APPLICANT'S SUPPLEMENTAL RESPONSE TO DATA REQUESTS 8 AND 16: ADDITIONAL INFORMATION REGARDING AIR QUALITY

Air Quality/Public Health Analysis for Two-Plant Design
Rio Mesa Solar Electric Generating Facility

AIR DISPERSION PLOT PLAN
COMMON AREA

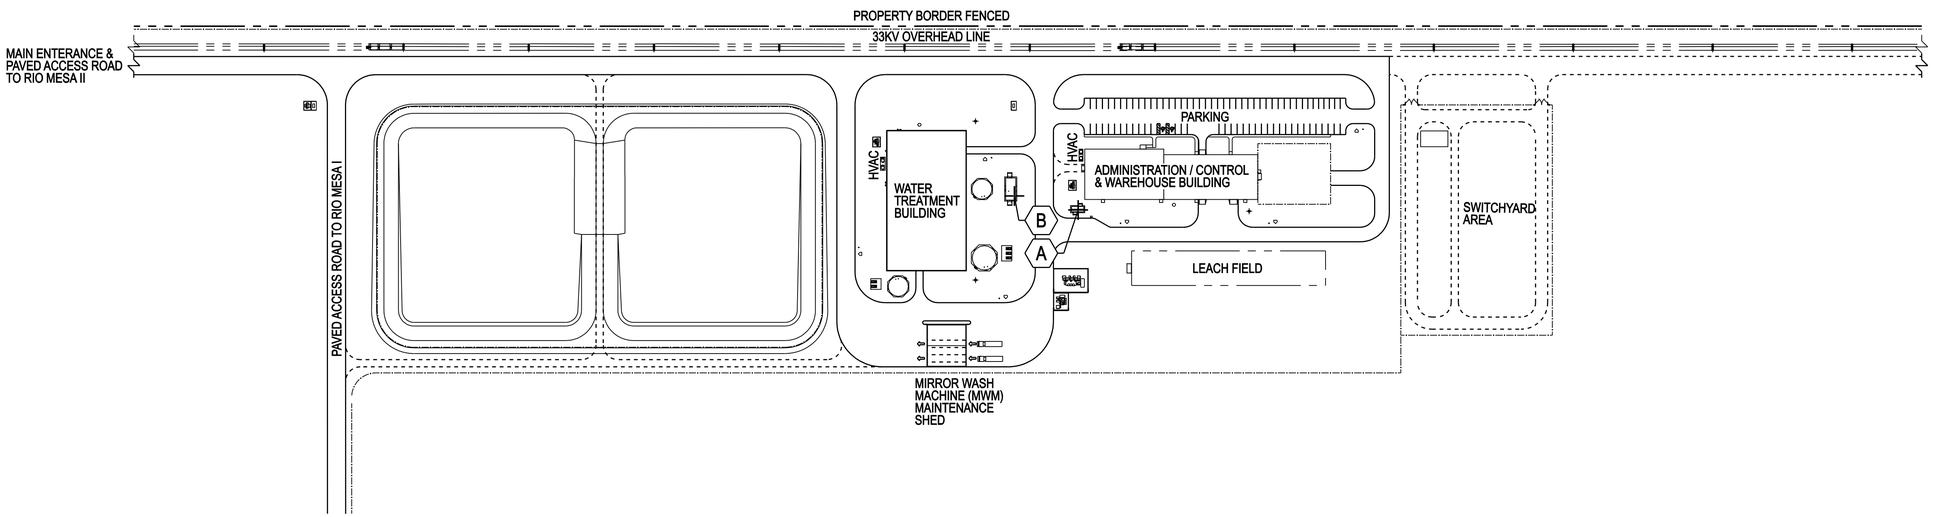
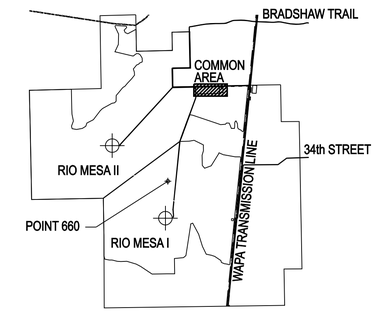
The enclosed analysis summarizes the changes to emissions, ambient air quality modeling impacts, and public health impacts associated with the two-plant design. The revised solar field layout and common area plot plan are included as Attachment 1, and detailed emission calculation summary tables for the two-plant design are included as Attachment 2 in the enclosed document. In addition, the detailed air quality modeling input/output files are included on the enclosed compact disc. We will send a separate confidential submittal to the District containing the spreadsheet with the detailed emission calculations for the two-plant design.

The Environmental Enhancement Proposal for the Proposed Project consists of removing one of the 250 MW (nominal) plants (removal of Rio Mesa Solar-III) and moving the common area to adjacent to the far northern reach of the Rio Mesa Solar-I solar field (see Attachment 1, Figures 2-5-R2 and 2-8-R2). The number and type of stationary equipment (boilers, emergency engines, wet surface coolers) and mirror washing equipment, including the operating profiles for this equipment, associated with the remaining two plants will remain identical to the information provided to the Mojave Desert AQMD (MDAQMD) and California Energy Commission (CEC) in April 2012 for the Boiler Optimization. In addition, the arrangement of the stationary equipment and equipment/building heights for each power block remains identical to the information provided to the MDAQMD/CEC for the Boiler Optimization.

1. DIESEL ENGINE EXHAUST HEIGHT TO BE 10 FEET OR HIGHER (TBD by SIERRA RESEARCH).
